Duke Power Company
ATTN: Mr. Austin C. Thies
Senior Vice President
422 South Church Street
Post Office Box 2178
Charlotte, North Carolina 28201

The Commission has issued the enclosed Amendment No. 6, Technical Specification Change No. 16 for License No. DPR-38; Amendment No. 6, Technical Specification Change No. 11 for License No. DPR-47; and Amendment No. 3, Technical Specification Change No. 3 for License No. DPR-55, for the Oconee Nuclear Station, Units 1, 2, and 3. These amendments are in response to your request dated September 20, 1974, and subsequent letters dated October 8, 1974, and October 31, 1974.

These amendments include the Technical Specification changes required for the second fuel cycle operation of Oconee Unit 1. The proposed Control Rod Withdrawal Limit For 4 Pump Operations (Figure 3.5.2-1A2) after 250 ± 5 full power days of operation has not been included in this change since it does not conform to the Interim Acceptance Criteria for ECCS and your proposed Final Acceptance Criteria (Appendix K) Technical Specifications have not yet been approved.

AMENDMENT NO. 6 TO FACILITY LICENSE NO. DPR-38,
CHANGE NO. 16 TO TECHNICAL SPECIFICATIONS;

Figure 3.5.2-3A 16/11/

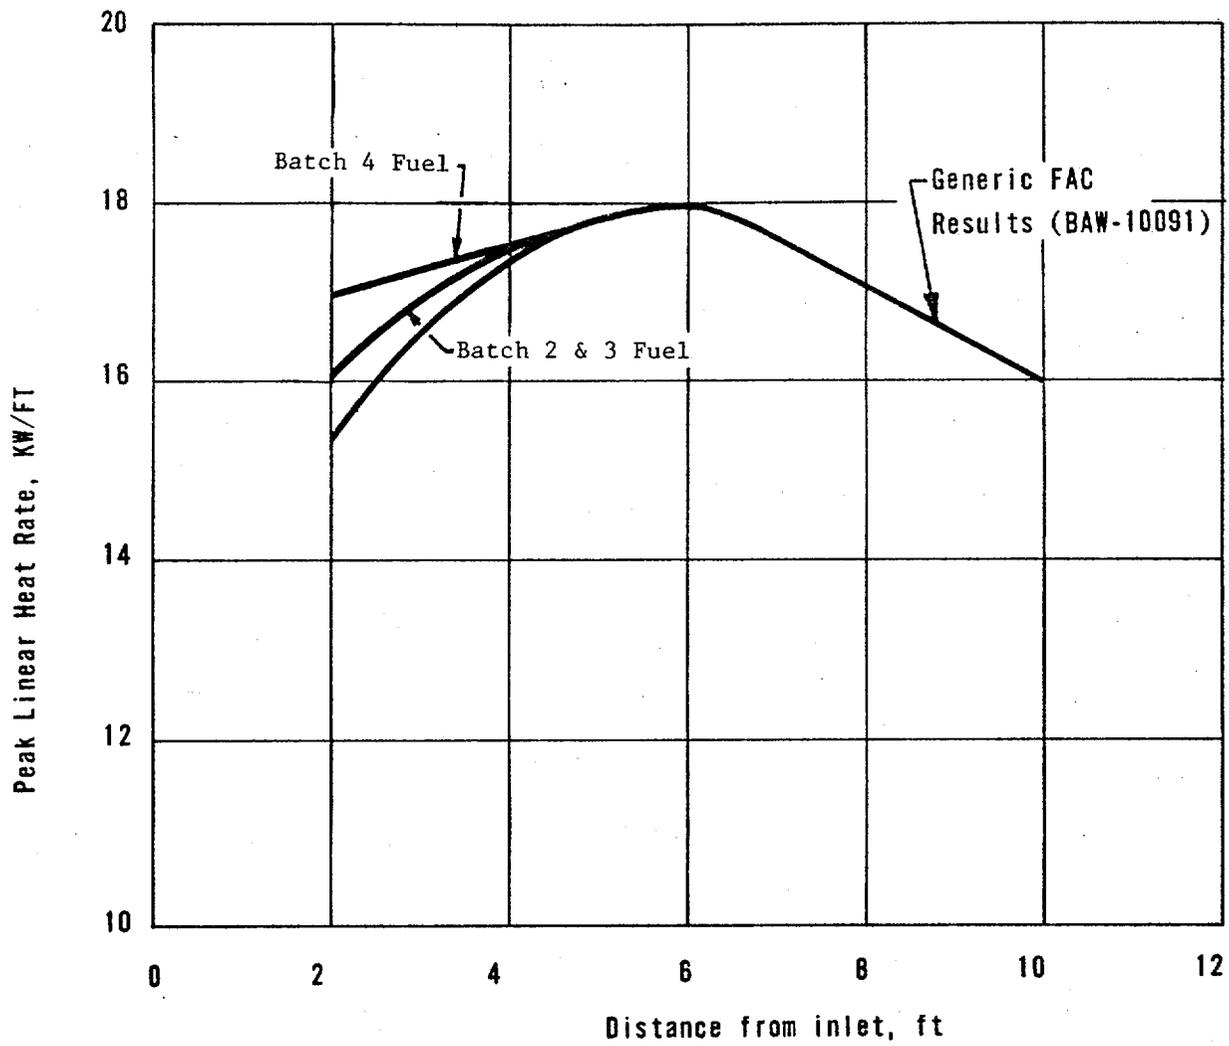
The power-imbalance envelope defined in Figures 3.5.2-3A, 3.5.2-3B, and 3.5.2-3C is based on LOCA analyses which have defined the maximum linear heat rate (see Figure 3.5.2-4) such that the maximum clad temperature will not exceed the Final Acceptance Criteria. Corrective measures will be taken immediately should the indicated quadrant tilt, rod position, or imbalance be outside their specified boundary. Operation in a situation that would cause the Final acceptance criteria to be approached should a LOCA occur is highly improbable because all of the power distribution parameters (quadrant tilt, rod position, and imbalance) must be at their limits while simultaneously all other engineering and uncertainty factors are also at their limits.** Conservatism is introduced by application of:

3.5.2.6 Reactor power imbalance shall be monitored on a frequency not to exceed two hours during power operation above 40 percent rated power. Except for physics tests, imbalance shall be maintained within the envelope defined by Figures 3.5.2-3A, 3.5.2-3B, and 3.5.2-3C. If the imbalance is not within the envelope defined by Figure 3.5.2-3A, 3.5.2-3B, and 3.5.2-3C, corrective measures shall be taken to achieve an acceptable imbalance. If an acceptable imbalance is not achieved within two hours, reactor power shall be reduced until imbalance limits are met.
